INSTRUCTIONS NO. 12

Propeller Modification For Franklin 6A8-215-B8F Engines  
Having Full Reverse Thrust Ball Bearing

VIEW LOOKING INTO CYLINDERSECTION A-A

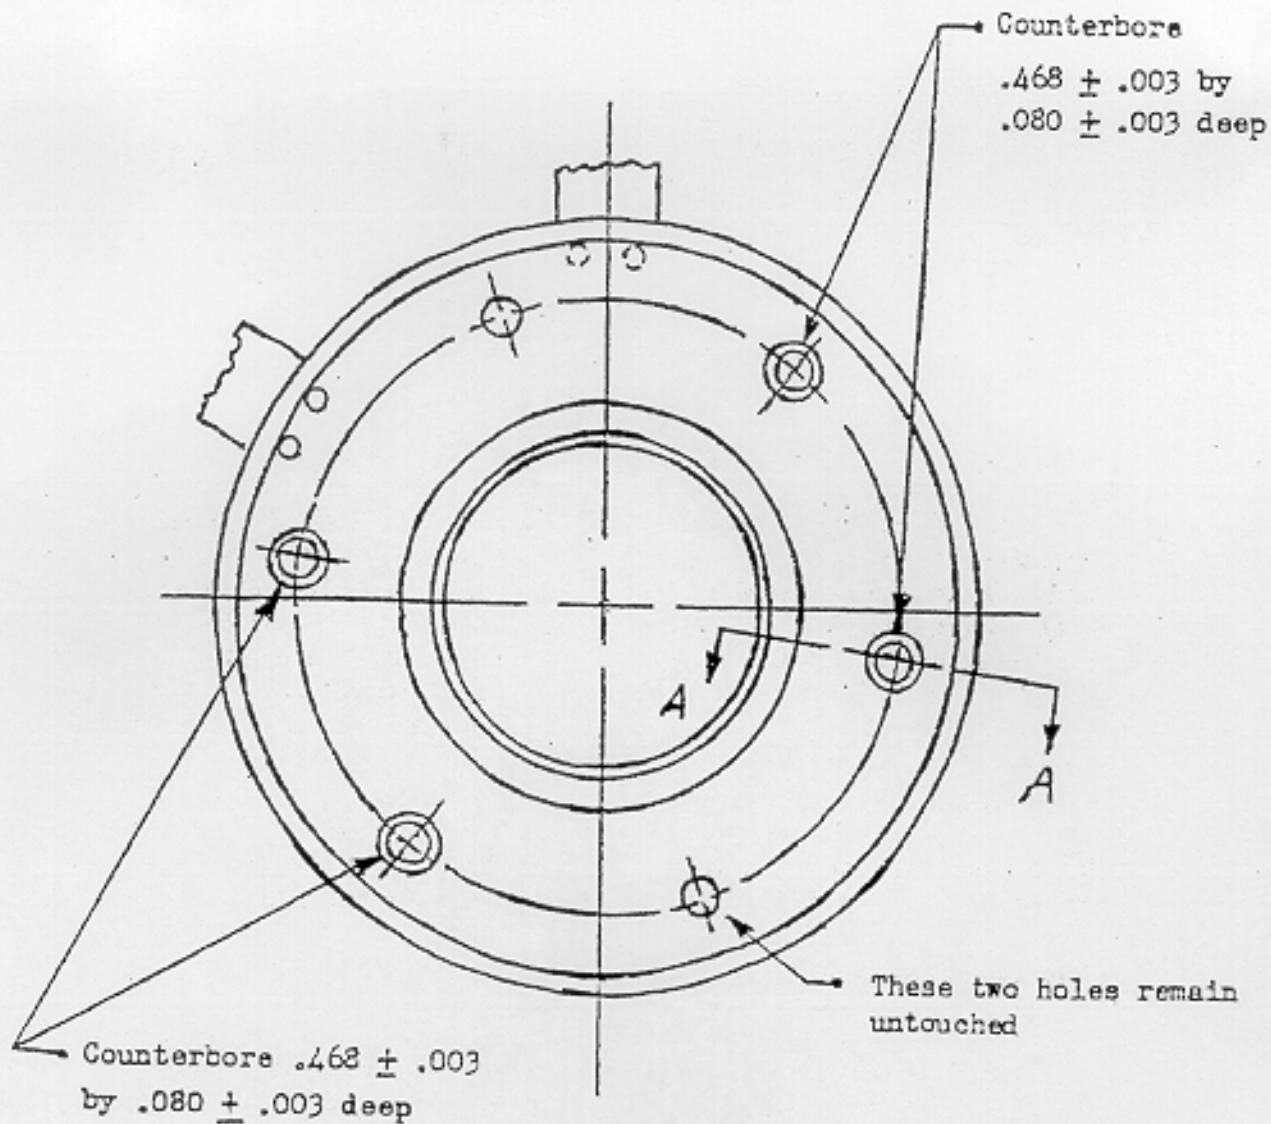
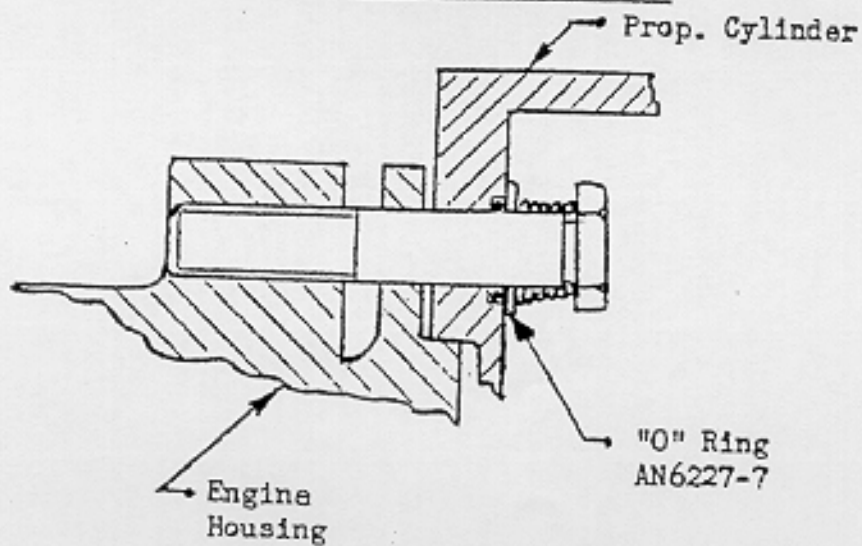
Any Franklin Engine serial number 23001 thru 23286 which is modified to incorporate a ball reverse thrust bearing in place of the original thrust washer type bearing in order to permit full 2500 RPM operation in reverse pitch must also have the propeller cylinder modified to accommodate the "O" ring seal required by four of the six new studs used on this installation. This is identical with the installations used on engines 23281 through 23500.

The propeller cylinder used on an engine so modified must have the four holes through which the spring loaded studs pass counterbored on the inside as shown in the accompanying illustration. AN6227-7 "O" ring fits into the counterbore and prevents the oil from leaking.

The counterbore should be concentric with the stud hole. The tolerances on both the .468 diameter and .080 depth are plus or minus .003.
